**Attachment 1**

**Current to Proposed Emergency Plan Comparison Review**

This comparison review identifies the differences between the current Emergency Plan (January 2018) and the proposed Emergency Plan. Differences of intent are further evaluated to determine whether the adoption of the proposed Emergency Plan would constitute a potential reduction in effectiveness from the current Emergency Plan.

**Proposed Emergency Plan Figure 3-1 – VNC Emergency Response Organization and Support Interface**

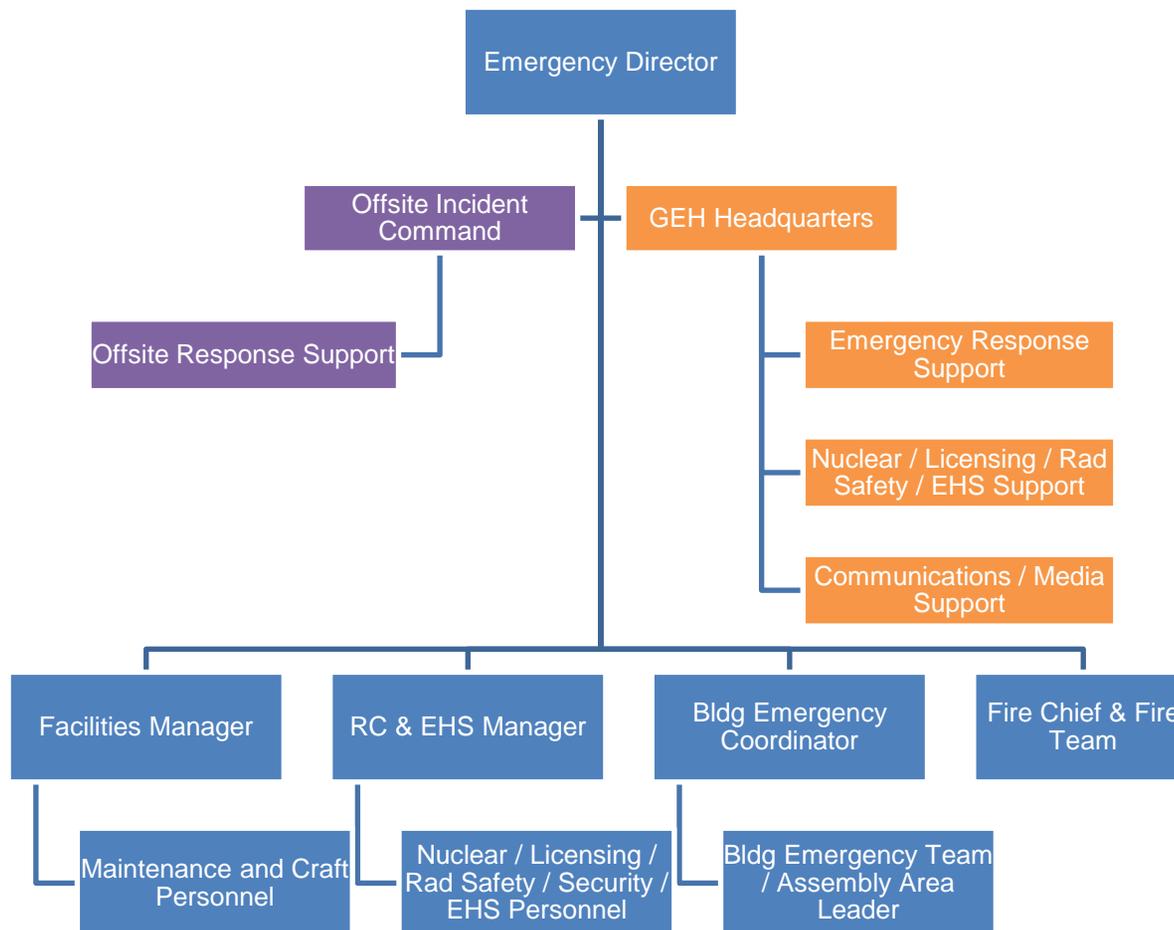
33.	<p><b>3.1.1 Emergency Director</b></p> <p>As part of overall command and control of the event, the Emergency Director coordinates the collection and evaluation of information from the event location, prioritizes response and mitigating activities of dispatched personnel, and manages the Emergency Control Center (ECC) and ERO in order to provide continuous assessment of the situation regarding the magnitude of the emergency, projected consequences, and effectiveness of the response measures taken. Specifically, the Emergency Director has the overall responsibility and authority for VNC emergency response activities, including:</p> <ul style="list-style-type: none"> <li>• Classifying and declaring emergencies</li> <li>• Designating a location for the ECC, [[ ]]</li> <li>• Ensuring notification of the VNC ERO and augmenting as necessary</li> <li>• Ensuring notification of the appropriate offsite agencies</li> <li>• Mobilizing corporate and other support resources as necessary</li> <li>• Coordinating response activities (including off-site assistance if requested) to mitigate the consequences of the event</li> <li>• Directing on-site protective actions to prevent or minimize personnel hazard and injury</li> <li>• Authorizing reentry into facilities or areas that may have been evacuated during the emergency</li> </ul>	<p><b>3.1 On-Site Emergency Control Organization</b></p> <p>.... From the moment he becomes aware of an emergency, an Emergency Operations Coordinator (EOC) is responsible for coordinating emergency response activities.</p> <p>3.1.1 [[ ]]</p> <p>]] has the responsibility and authority to declare an emergency whenever, in his opinion, it is warranted by an incident or condition that involves an actual or potential degradation of the level of safety of a facility or the site.</p> <p>The responsibility and authority for directing and coordinating emergency response activities are assigned to the Emergency Operations Coordinator (EOC). Duties and authorities of the EOC during initial and secondary phases of an emergency are discussed below.</p> <p><b>3.1.2 Emergency Operations Coordinator</b></p> <p>The EOC has the responsibility and authority for the following:</p> <ol style="list-style-type: none"> <li>1. Initiation and implementation of the emergency plan and procedures, including declaring the emergency, notifying offsite agencies, and making protective action decisions, and coordination of emergency response activities of the Emergency Control Organization (and off-site assistance) for the duration of the declared emergency. These responsibilities can only be delegated to personnel qualified as an EOC.</li> <li>2. The Initial Response EOC shall coordinate activities until relieved by the Secondary Response EOC; his duties and responsibilities include:</li> </ol>	<p><b>Non-RIE</b></p> <p>Specified ED responsibilities were organized and aligned to the current REP and SRP.</p> <p>Also, eliminated terms for EOC initial response phase and secondary response phase. Establishing initial and secondary EOC responders provided a means for a seniority based augmentation and assumed two individuals be simultaneously available. The proposed REP does not require ERO relief based on seniority, but does not prevent it if a more senior staff member qualified as ED desires to relieve the ED in charge of the event. Typically, a single ED remains in charge until relieved by another ED for shift relief or when the event is terminated. All EDs are trained and qualified to fully perform the responsibilities of the position.</p> <p>Refer to Changes #31 and #35 for RIE discussion relaxing ED presence onsite 24/7.</p>

35.	<p>3.1.3 [[  ]]. This includes dose assessments and recommendation of on-site protective actions as appropriate.</p>	<p>3.1.3 [[  ]] This position is the Initial Response EOC and will respond to an emergency and make an assessment. When acting as the Initial Response EOC, this position is responsible for immediate corrective and protective action and for calling for assistance if required. If assistance is required for corrective and protective action or additional assessment action, [[  ]] is responsible for directing these activities until relieved by [[  ]] or his emergency response alternate. [[  ]] absent from the emergency communications center, a designated individual (site security or other personnel) will be responsible for communication; [[  ]].</p>	<p><b>RIE</b>                      The proposed REP does not require an Emergency Director (previously titled EOC) to be on site 24/7.</p>
